New Meters, Allocations & Expansion of Services Committee Agenda

Review of Application for Will Serve Letter

New 748 sqft ADU for Property with Existing Meter at 165 S. Alvarado.

DATE

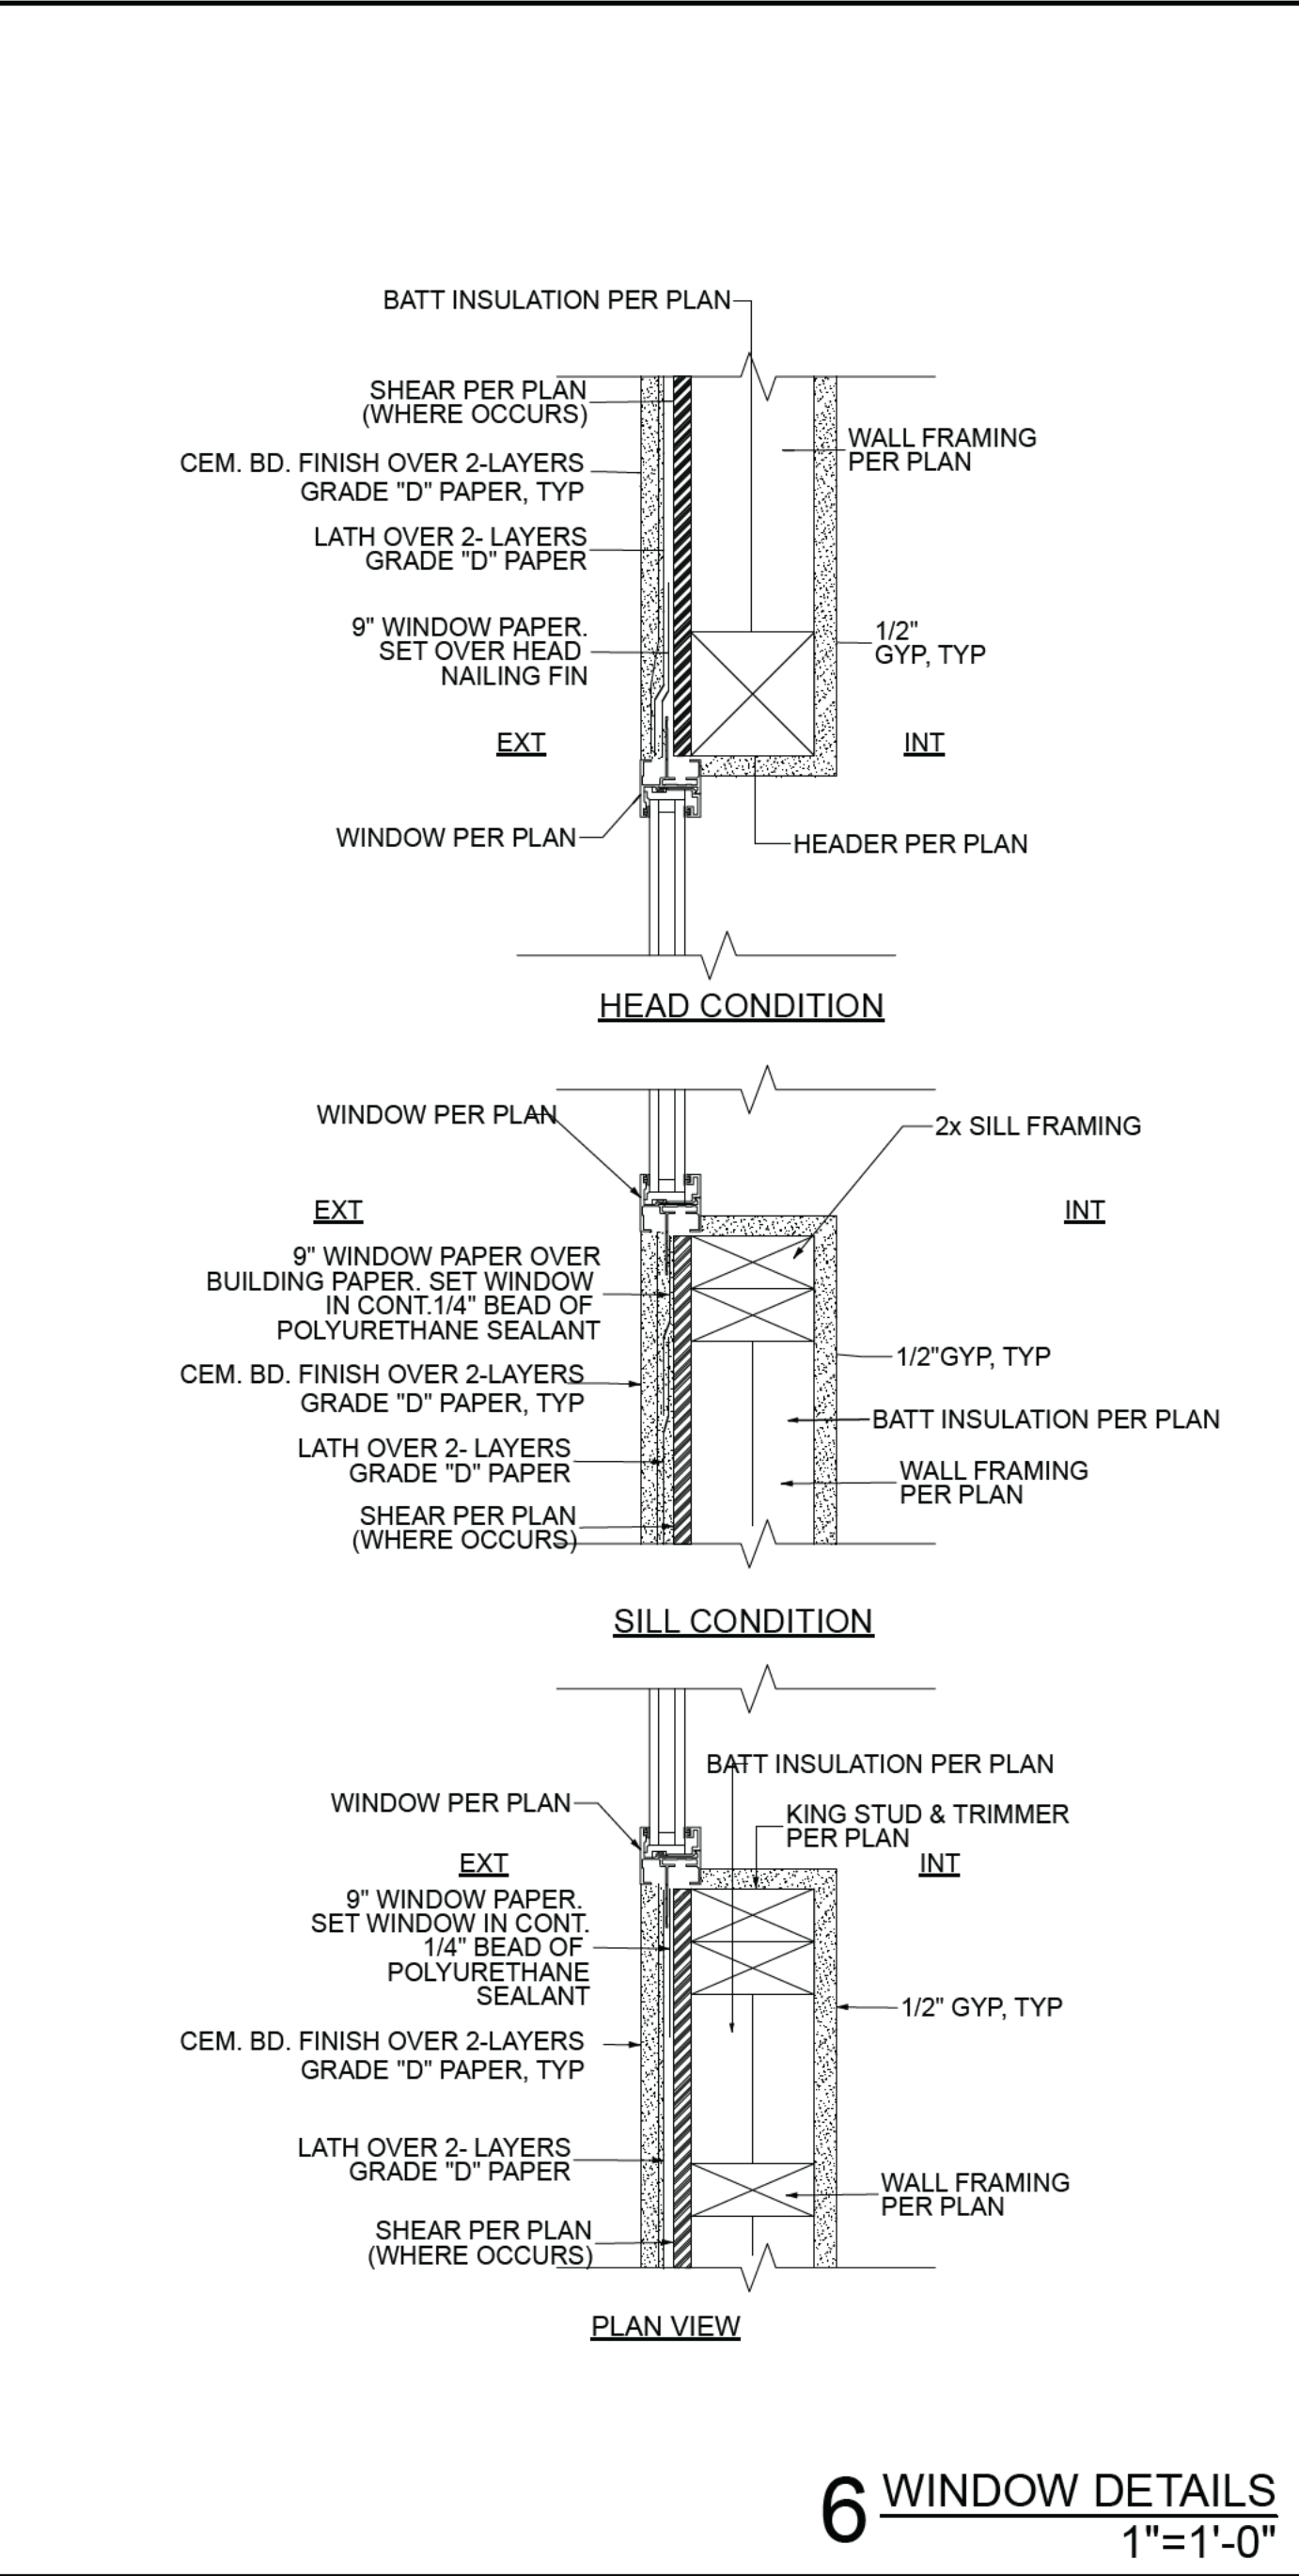
The proposed project consists of adding a new 748 sqft, 2-bedroom + 2 bathroom ADU. The applicant provided a detailed site plan showing the location of the proposed structure.

- *Recommend purchase of at least 36 HCF from Casitas MWD to support ADU and 15 HCF for outside irrigation.*
- Letter applies only to the proposed ADU as described in the applicant-provided preliminary site plan with the filing date of 8-15-2023.
- **There will be no increase in the total (fixed plus variable) water allocation assigned to the meter Will Serve Letter will expire after 1 year.**

SITE PLAN
SCALE: 1/4" = 1'-0"

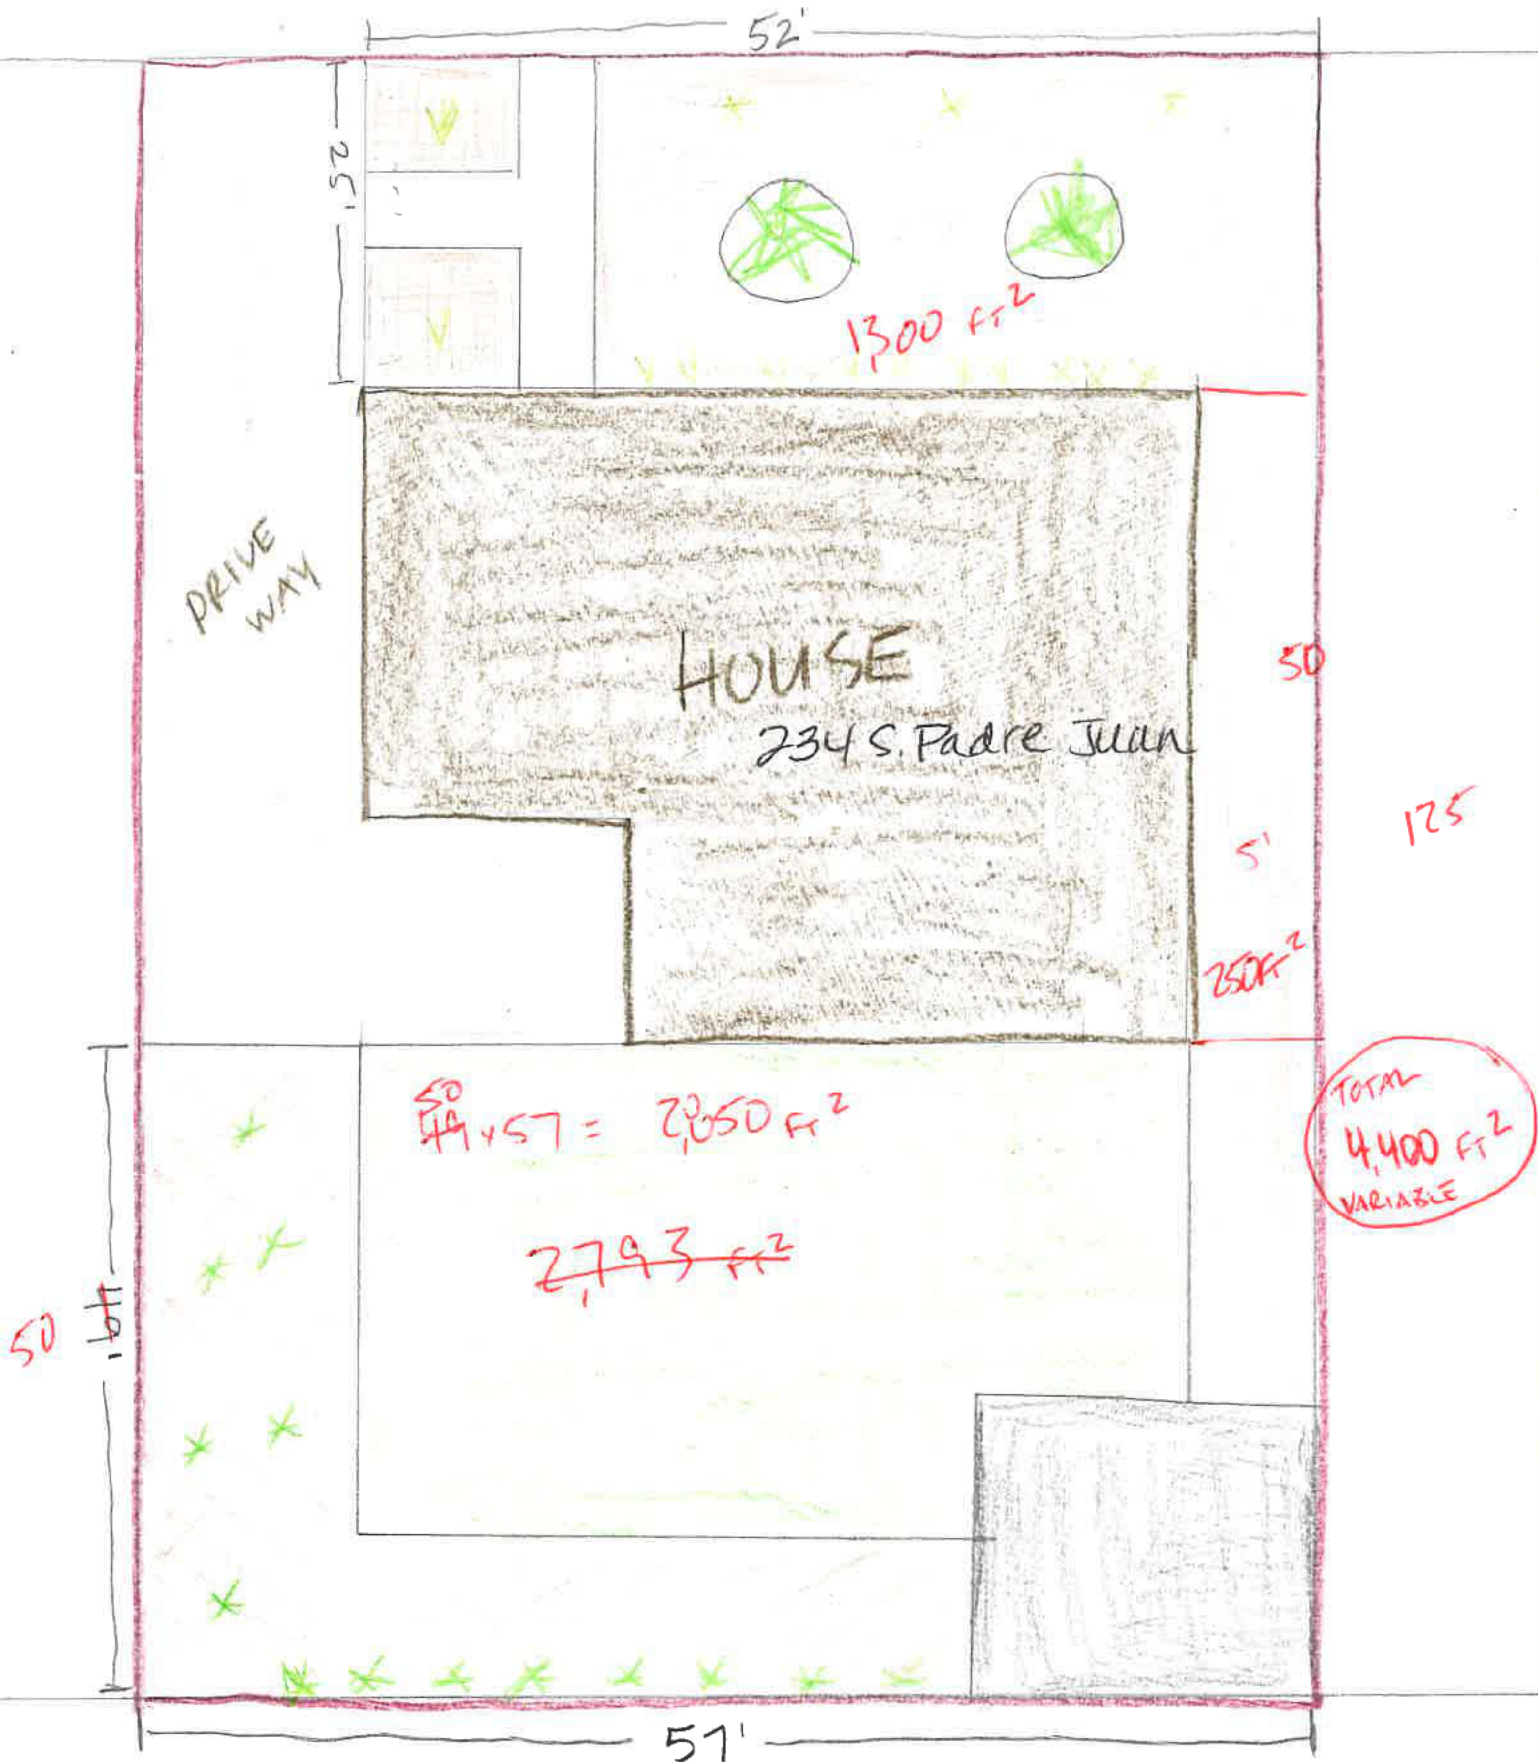
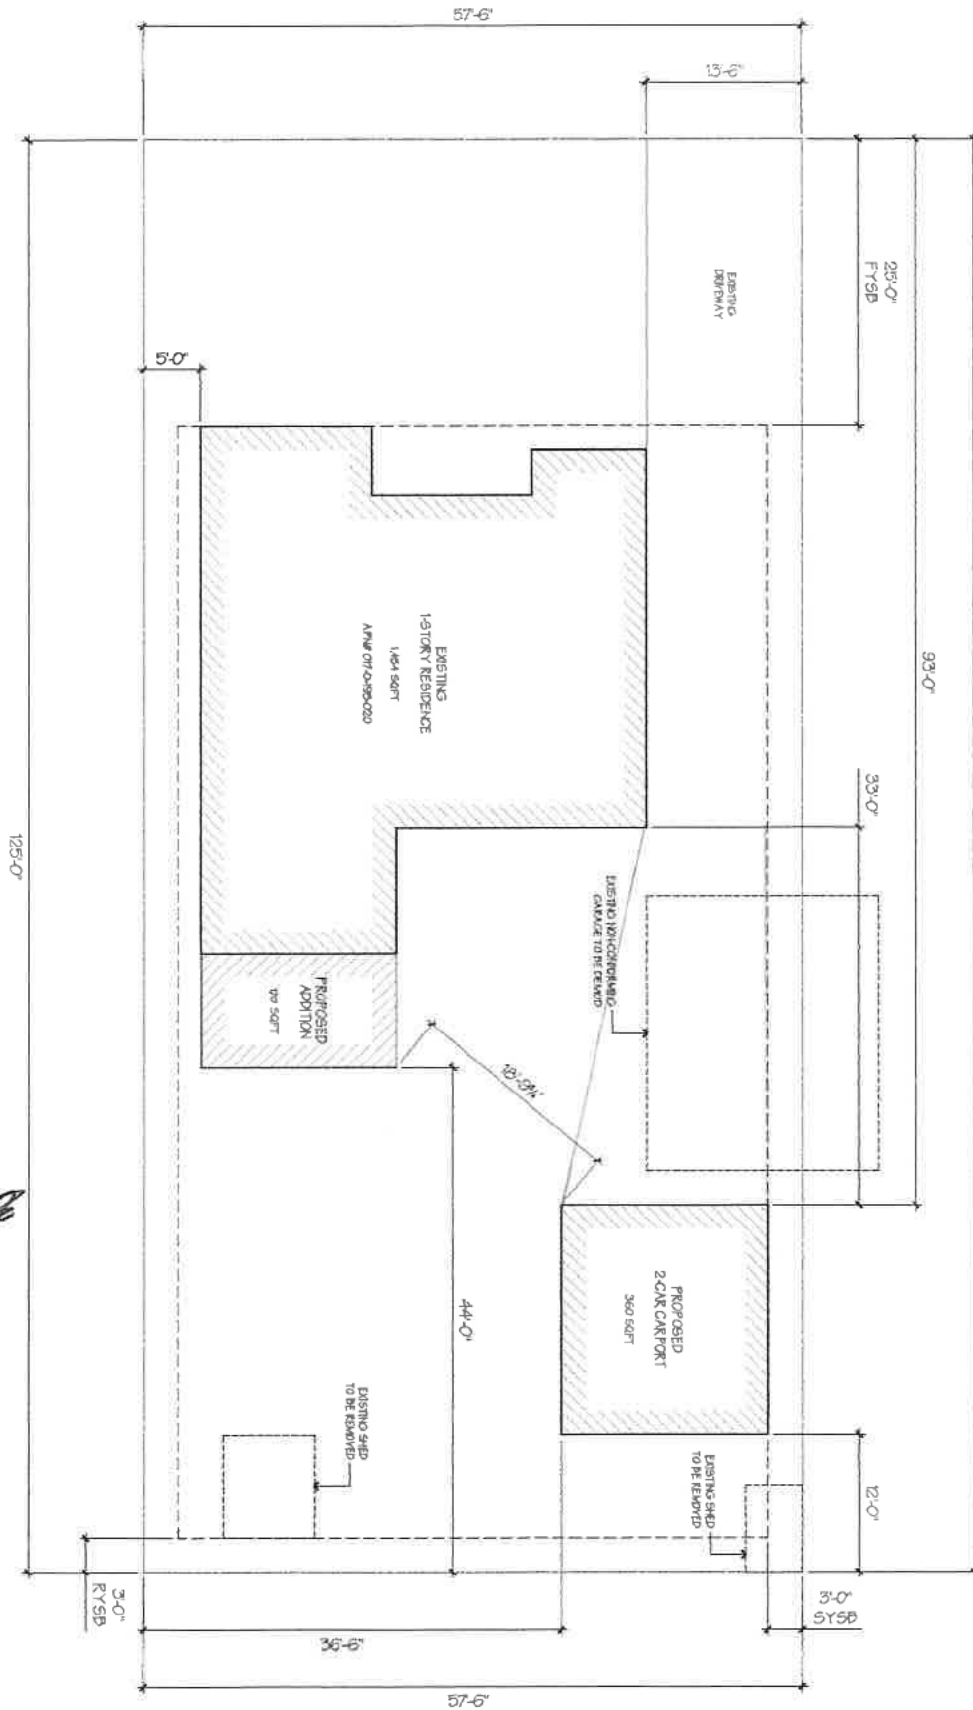
APN	Parcel_Area	F1_Imperv	F2_Pool	F3_IrrgVeg	F4_Irrg_TurfLawn	F5_NL	F6A_NotIrrg_TurfLawn	F6B_NotIrrg_Misc	F6C_NotIrrg_Veg	F7_ArtificialTurf	F8_AnimalArena	F10_Agriculture
234 S PADRE JUAN	17019503	7194	5116	0	0	0	0	507	1472	99	0	0	0
Post Construction													
Revised Variable		4400	sqft										
		66000	gal										
			66000	88	units/yr								
246 S PADRE JUAN	17019502	7189	3491	0	0	177	0	2797	0	724	0	0	0
Post Construction													
Revised Variable		6421	sqft										
		75000	gal										
	1421	14210	gal										
		89210	total gal	119	units/yr								
Historical Allocation Information													
Original Database													
2 Dwellings - 1 meter	Fixed	10	units/mo										
2 Parcels	Variable	245	units/yr										
Adjusted for Dwellings	Fixed	14	(each dwelling 7 units/month)										
	Variable	111											
					Post Construction Recommended Allocations								
Adjusted for 2 Primary	Fixed 1	10	units/mo		10 units/mo

Will Serve Letter	Fixed 2	10	units/mo		10 units/mo								
	Variable 1	60	units/yr		88 units/yr								
	Variable 2	60	units/yr		119 units/yr
